BEFORE THE PUBLIC UTILITY COMMISSION

LC 80

2023 Integrated Resource Plan and Clean
Energy Plan.

ROUND ONE COMMENTS OF THE
SWAN LAKE AND GOLDENDALE
ENERGY STORAGE PROJECTS ON
PORTLAND GENERAL ELECTRIC
CO.'s 2023 CLEAN ENERGY PLAN
AND INTEGRATED RESOURCE
PLAN

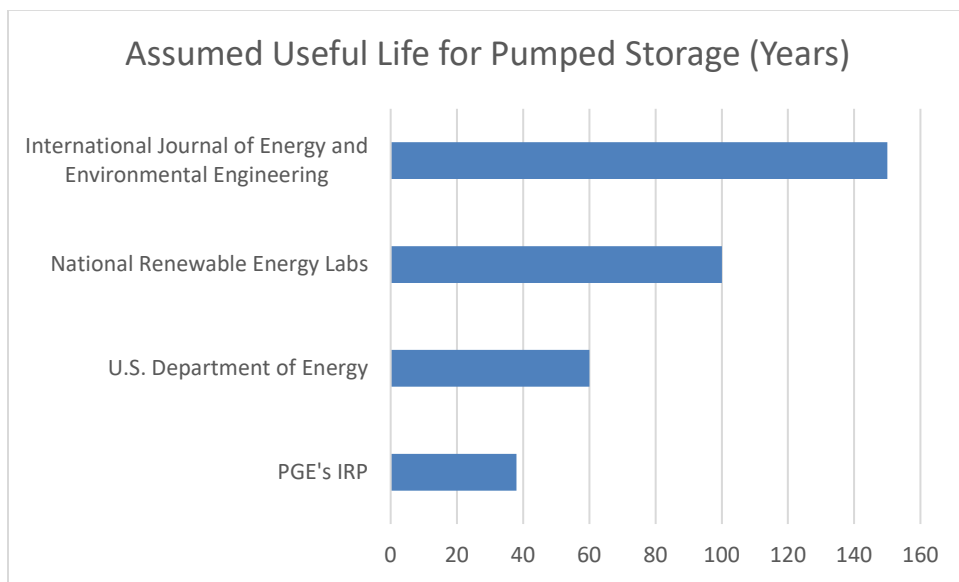
Second, a 38-year useful life is inconsistent with the vast majority of available literature regarding the useful life of pumped storage facilities. To visually demonstrate the inconsistency, the Projects have created a graph to show how different sources have assumed the useful life of pumped storage, in stark contrast to the short, 38-year useful life used by PGE³:

As demonstrated in the visual above, PGE’s selection of 38 years is an outlier compared to the majority of highly respected sources, all of which assume a useful life for pumped storage that

ranges from 60 years at the low end to 150 years at the high end. The Projects believe that given the evidence, a 38-year useful life is not justifiable and should be, at a minimum, 50 years in this IRP – which is still lower than the lowest useful life available in the literature cited above.

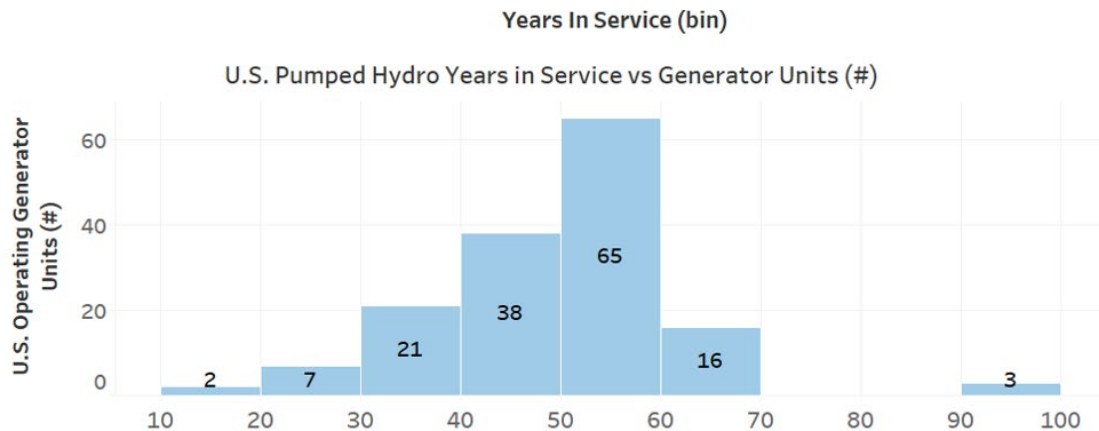
Third, a 38-year useful life is inconsistent with actual operating information of all pumped storage facilities currently in operation in the United States. The U.S. Energy Information Administration (“EIA”) collects annual generator-level information about pumped storage facilities. In June of this year, the EIA released data, which the Projects have converted into the graph below, that shows the age distribution of the U.S. pumped storage fleet in 2022. It is notable that no unit retired in 2022 – meaning that all 150 units appear to still be operating, with over half of them operating for over 50 years:⁴
